WODC planning application 16/02306/FUL: Land Rear Of 15 And 16 Woodstock Road Charlbury Oxfordshire.

View Based on Plans Submitted by Cottsway

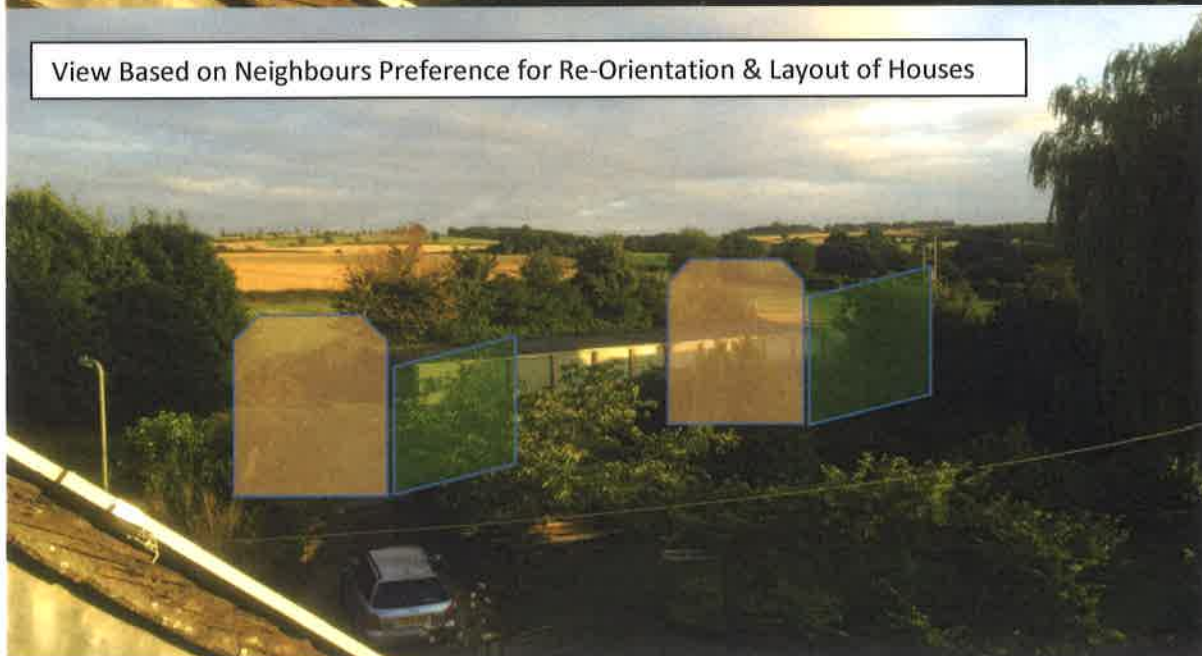
They fail to respect the privacy of the existing houses, and fail to maintain a satisfactory environment for them, and for the residents of the new units. The new block is un-neighbourly and overbearing.

And as such, I urge the applicant to make significant changes to the layout and configuration.

I have here visual renderings that illustrate a huge difference that a simple change in orientation would make.

The community and Parish Council agree there is a need for affordable housing in Ascott; that this is the appropriate place; and that six units is not an over development of the site. However there is a huge problem with the layout design. The site extends to 1577 sq. m. and the application for six units is not a challenging density, alternative layouts are possible.

The Design and Access Statement refers to “rural vernacular typically found in and around village greens” but this is a different environment and comprises council houses from the 60s and 70s with long gardens, and open outlooks. This scheme includes an unbroken terraced block, 71’ long and 31’ high at right angles to the existing houses in Maple Way and set back only 19’ from the new boundary. This block overshadows the gardens of 18 in particular. Despite Officer comment it will exclude the sun in winter months for most of the day. The first floor windows of the new houses look directly in to the gardens of 18 and 16 Maple Way which will have no privacy. We question that bedrooms are not regarded as habitable rooms - but in any event they will eliminate any sense of privacy in the existing gardens, and those of the new houses. Other concerns including issues of drainage, traffic and the natural environment have been addressed in the draft conditions but parking arrangements especially those for 15 Dawls Close remain outstanding.

View Based on Neighbours Preference for Re-Orientation & Layout of Houses

Plan View Based on Neighbours Preference for Re-Orientation & Layout of Houses
